Docket Item # 2
BAR CASE # 2011-0093

BAR Meeting
May 18, 2011

ISSUE: Signage and Awnings
APPLICANT: Lee Choe
LOCATION: 1609 King Street (Uptowner Café)
ZONE: KR / King Street Retail

STAFF RECOMMENDATION: Staff recommends approval of the Certificate of Appropriateness application with the following conditions:

Figure 1: Proposed Signs and Awnings

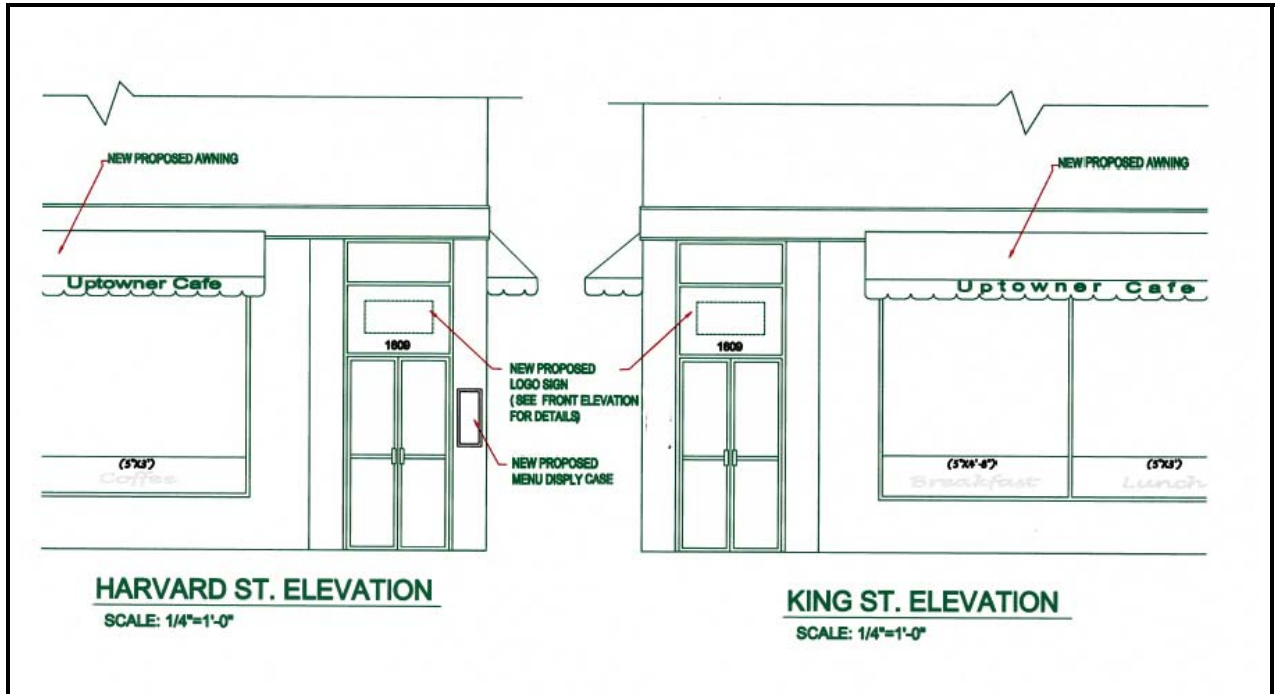
As it is not specified in the applicant’s description, Staff recommends a condition of approval specifying that the awnings are anchored to the masonry building through the mortar joints.

Figure 5: Proposal – Menu Display Case

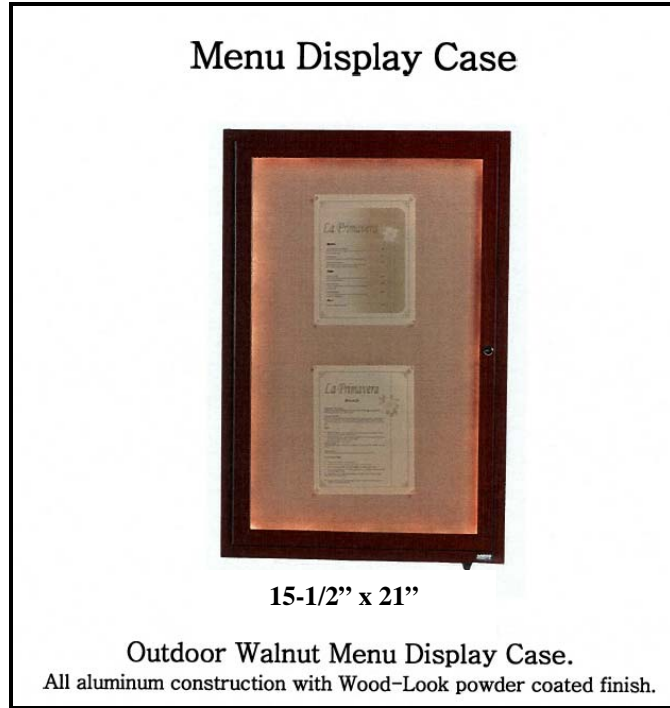
Staff’s only concern with the application is with the proposed size of the menu display case. As shown in the below photo, there is a space limitation in the location to the right of the entry door, as the building has brick detailing that needs to remain exposed. Therefore, Staff is recommending that the width of the menu display case does not exceed 14 inches.

1. That the width of the menu case does exceed (14”) fourteen inches.
2. That the awnings are mounted through the mortar joints and not the brick.
3. That the existing hanging sign mounted on the sign bracket is removed.
4. That all the existing window and door signage and vinyl decals are removed.
5. That the menu board is not internally illuminated.
6. That any proposed changes to the exterior lighting will return to the BAR for review and approval.

Figure 6: Proposal – Signage to be Removed/Retained

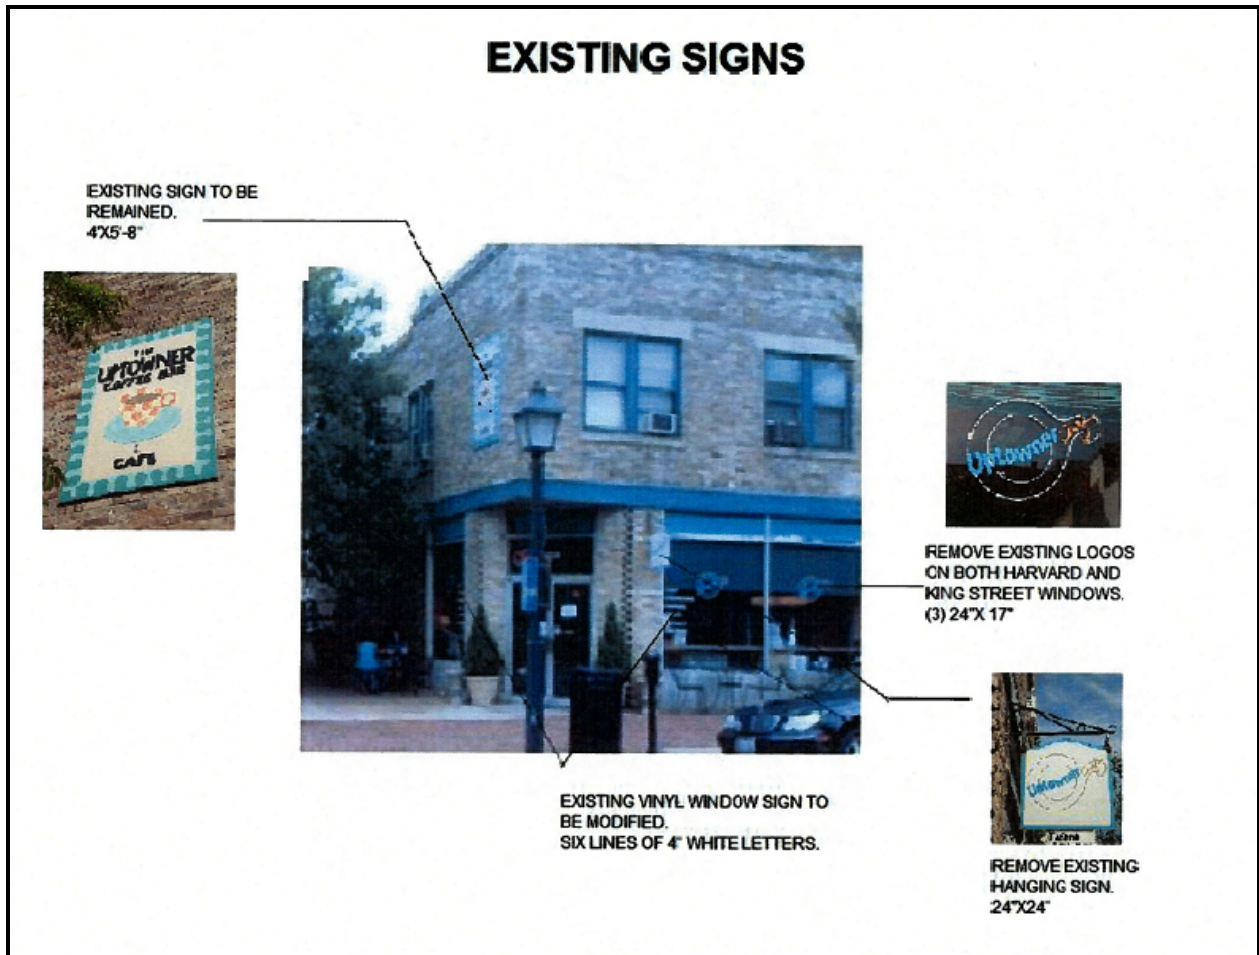
- Existing wood band board above the first floor and replacing it in-kind.
- Existing “Uptowner Café” hanging sign hung from the sign bracket on the King Street elevation.
- Existing “Uptowner Café” logos from Harvard and King Street Windows.
- Existing vinyl lettering on windows.
- All other window and door signage.

F-1 Existing window signs and hanging sign are to be removed.
